Remedial Action Plan

DuPont Brevard Site

September 23, 2016

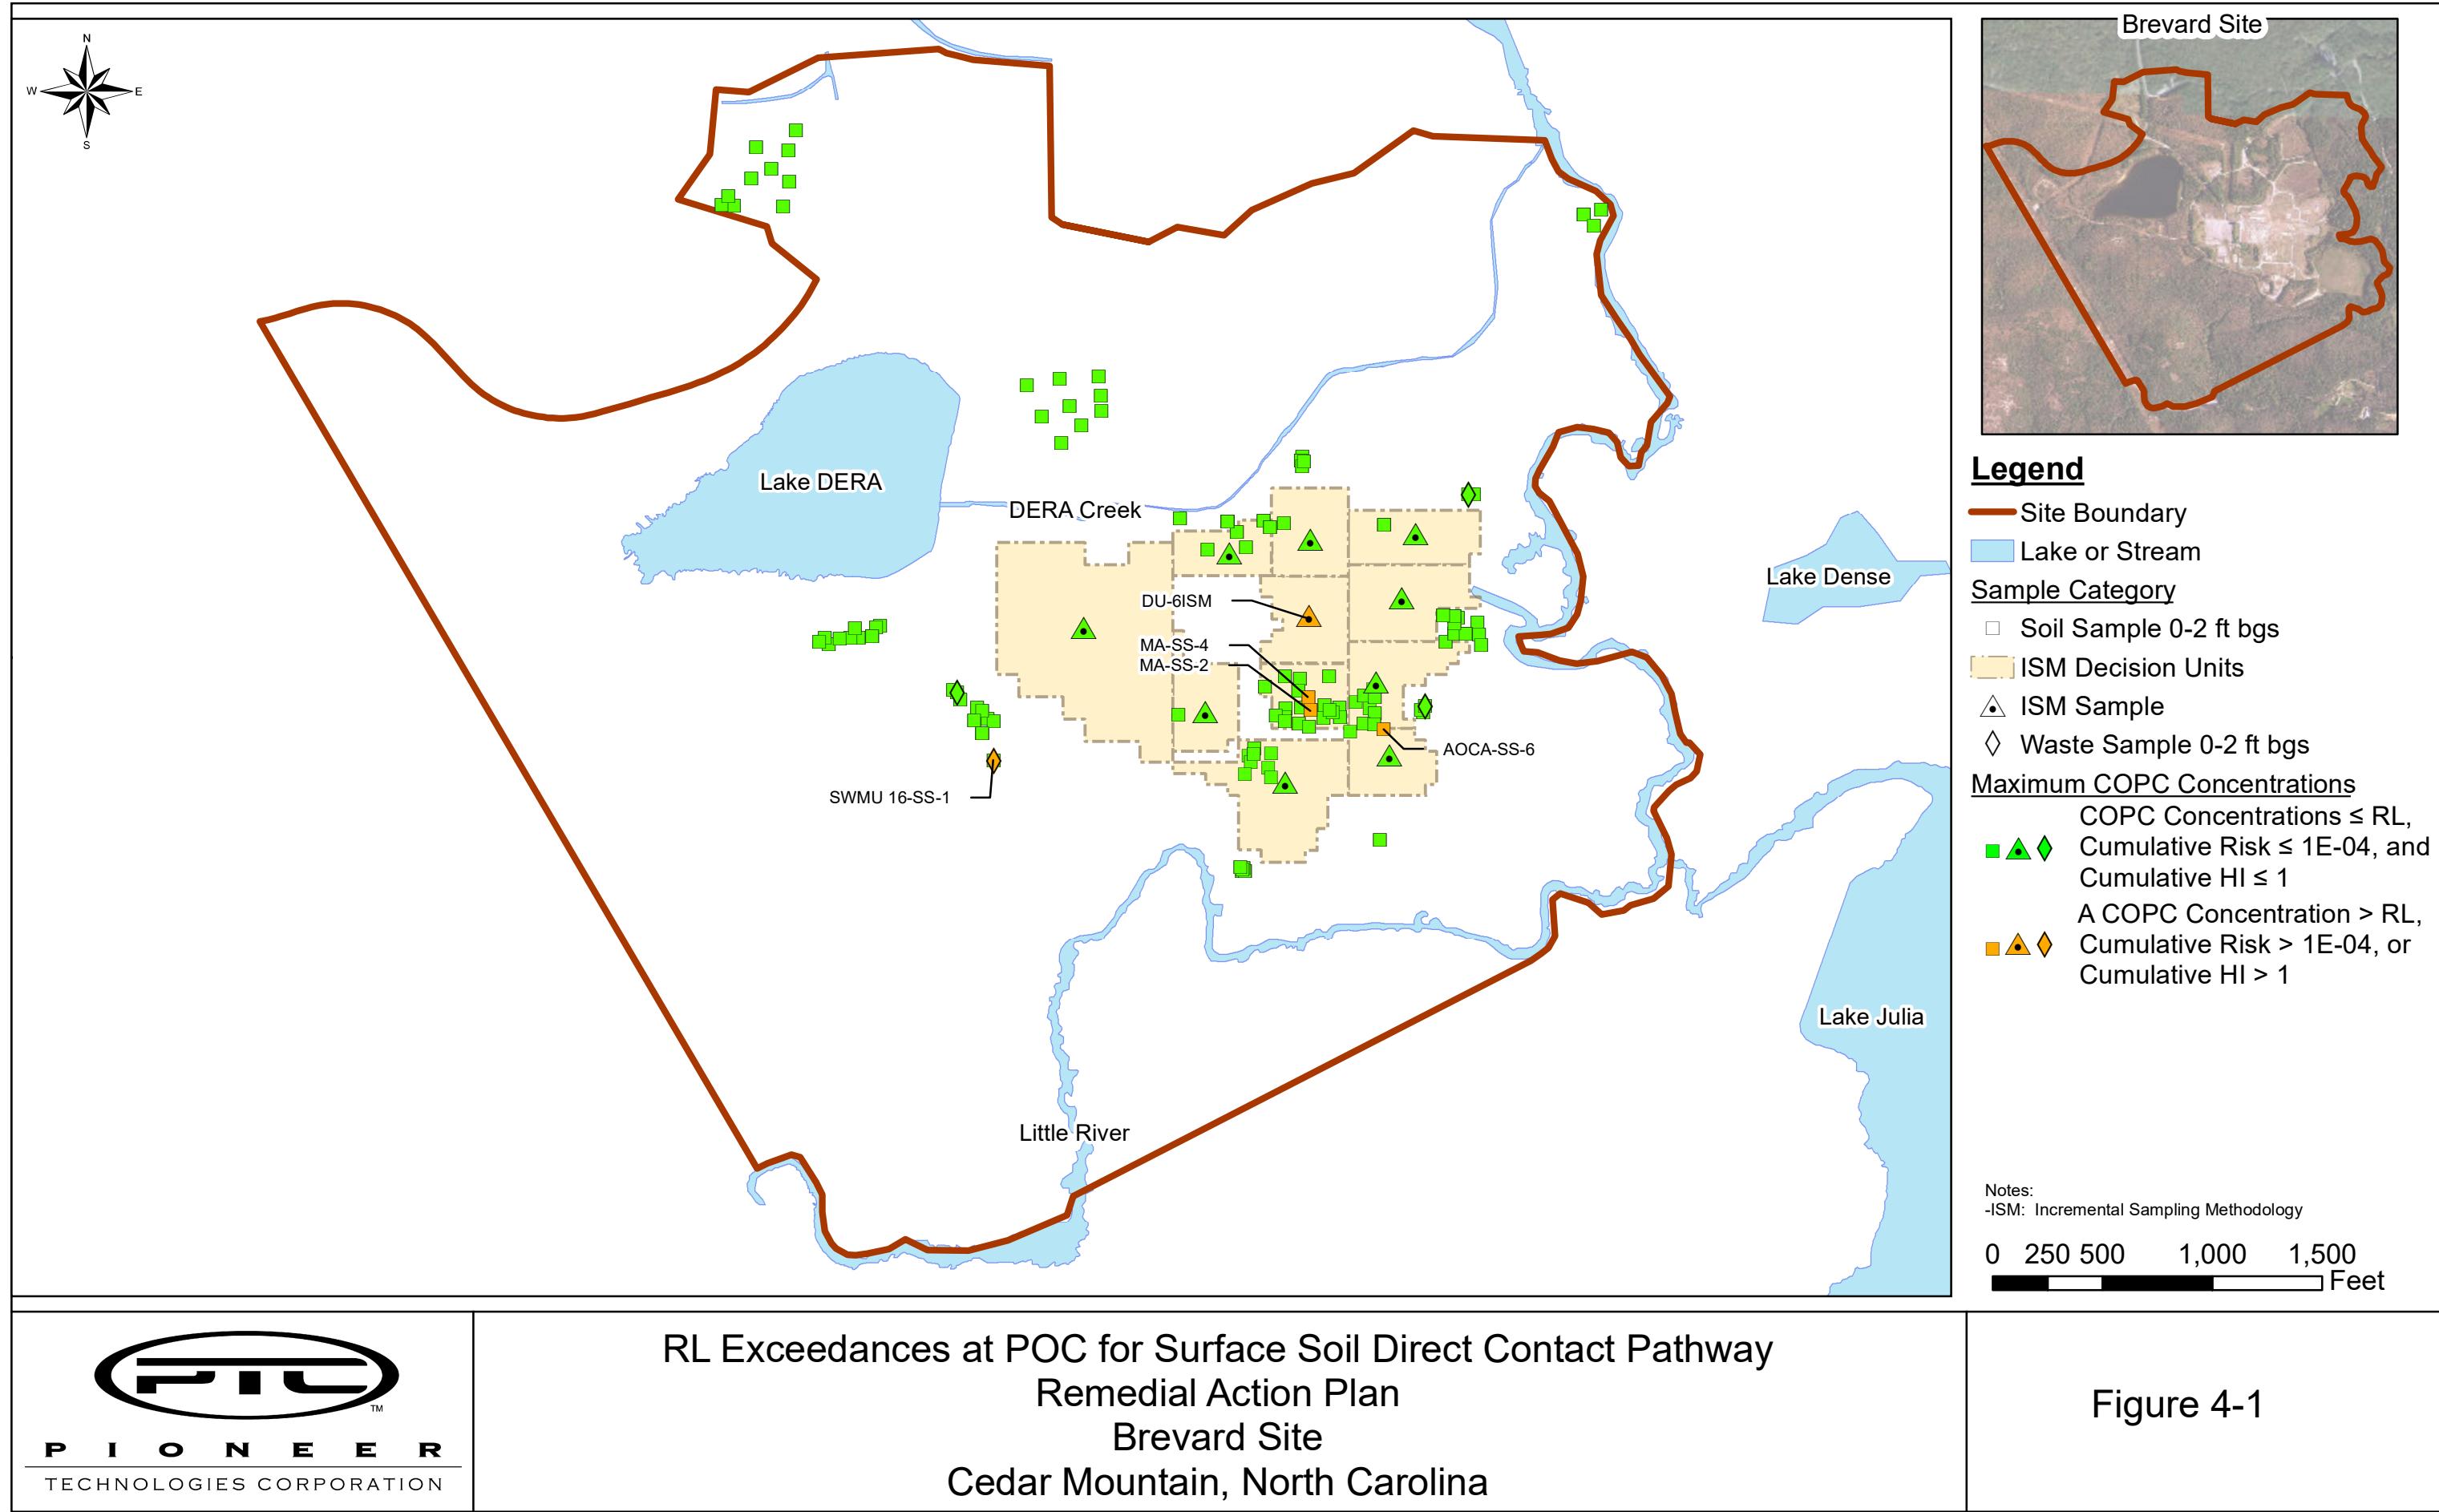
#	Comment	DuPont Response	RAP Update
5.	Section 2.8 – AOC 2C should be moved from NFA to the category that requires notification and sampling prior to excavation.	Before the RAP is submitted to NCDEQ, Section 2.8 and Figure 2-9 will be revised to clarify that all SWMUs and AOCs located in the former manufacturing area, including AOC 2C, are considered Test Before Dig Areas and must be sampled prior to any excavation activities.	Section 2.8 and Figure 2-9 were updated to clarify that all SWMUs and AOCs located in the former manufacturing area, including AOC 2C, are considered Test Before Dig Areas and must be sampled prior to any excavation activities.

7.	Section 2.8 – See comment 3.	Before the RAP is submitted to NCDEQ, Section 2.8 and Figure 2-9 will be revised to clarify that all of the SWMUs and AOCs located in the former manufacturing area are considered Test Before Dig Areas and must be sampled prior to any excavation activities.	Section 2.8 and Figure 2-9 were updated to clarify that all SWMUs and AOCs located in the former manufacturing area, including AOC 2C, are considered Test Before Dig Areas and must be sampled prior to any excavation activities.

8.	Section 2.8 - AOC A is listed as Further Action Needed in this Section. The status of this AOC should be clarified.	Before the RAP is submitted to NCDEQ, Section 2.8 and Figure 2-9 will be revised to clarify that all of the SWMUs and AOCs located in the former manufacturing area are considered Test Before Dig Areas and must be sampled prior to any excavation activities.	Section 2.8 and Figure 2-9 were updated to clarify that all SWMUs and AOCs located in the former manufacturing area, including AOC 2C, are considered Test Before Dig Areas and must be sampled prior to any excavation activities.
